AGENDA - TROY PLANNING COMMISSION MEETING
WEDNESDAY, JUNE 26, 2024, 3:30 P.M.
CITY HALL, COUNCIL CHAMBERS

A regular meeting of the Troy Planning Commission was held in Council Chambers, City Hall, Wednesday, June 12, 2024, at 3:30 p.m. with Chairman James McGarry presiding. ATTENDING: Members – McGarry, Emerick, Wolke and Titterington; Development Staff – R. Long; A. Eidemiller, T. Bruner, and Development Director Davis.

HISTORIC DISTRICT APPLICATION - CERTIFICATE OF APPROPRIATENESS. 15 S. MARKET STREET. FOR EXTERIOR ALTERATIONS OF PAINTING BRICK FACADE, INSTALLATION OF CORRUGATED METAL FLOWER BOXES AND AWNINGS; TWO SPOTLIGHTS ON STOREFRONT. OWNER / APPLICANT - TECUMSEH OF TROY, LLC/ BETH KERBER. Staff reported: zoning is B-3, Central Business District; OHI forms describe this building as a three-story commercial building with three or more bays; contributing features include the size and placement within the plane of the commercial streetscape; previous alterations covered the original characteristics of the building until the owner removed all of the metal that was hiding the original characteristics.

Alteration #2: Installation of corrugated metal flower boxes and awnings.

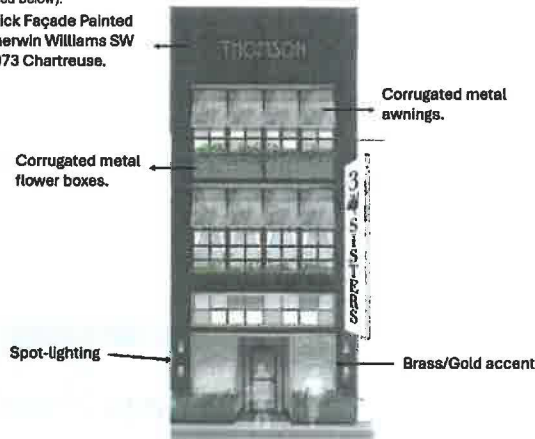
- A. Lighting should enhance the site and the building's design in a manner that is sensitive to surrounding properties. Light fixtures should be scaled appropriately based on the use and character of surrounding properties. *Although the lights appear to be sensitive to surrounding properties, not enough detail was submitted with the application to ensure this.*
- B. Light fixtures should be simple in design. Subdued, soft, warm lighting should be used. Avoid large, ornate light fixtures. *Not enough information was submitted to verify this.*

1. The brick is historically unpainted and includes character defining features. Brick soldiers and other bands exist around both the second and third story windows and the Thomson Sign at the top. The proposed paint will hide those features and otherwise detract from the historic integrity of the building, and;
2. The proposed awnings do not complement the building or streetscape; and are not fabric as required by the Design Manual, and;
3. Not enough detail on the lights is provided to ensure that the lights are simple in design, subdued, and warm lights.

DISCUSSION. Mr. McGarry commented that without design details of the awning, the corrugated flower boxes, the finish or appearance, it is difficult to evaluate the application, and he would like to see some form of awning detail, a 3D view or side view, to show comparison to other buildings in the downtown, and have samples of the materials to view.

Mr. Emerick asked about some form of border or detail around the brick soldiers, and Mrs. Kerber stated she could do that. Mr. Emerick commented that a metal awning would have sharp, hard edges that do not blend with the streetscape and metal would have some corrosion; he understands cloth fades, but it also has character and is seen all over the downtown. Mrs. Kerber commented that cloth awnings may be all over the downtown, but the awnings are in poor repair; she is willing to do hammered copper, which will weather; she believes the building is a more masculine and edgy building, and the metal is appropriate, but the metal awning can be rounded or softened; and since the design was prepared prior to the design standards being established, Mrs. Kerber suggested the standards should not apply.

A motion was made by Mr. Titterington, seconded by Mr. Wolke, to table the application for 15 S. Market Street until the applicant could provide more detail regarding elements of the proposal (corrugated flower boxes, the finished appearance, 3D or side view of the awning, possible alternatives to painting the brick, etc.) possibly present alternatives to painting the brick, and that this information could hopefully be considered at a meeting when more members could be present. MOTION TO TABLE ADOPTED, UNANIMOUS ROLL CALL VOTE.
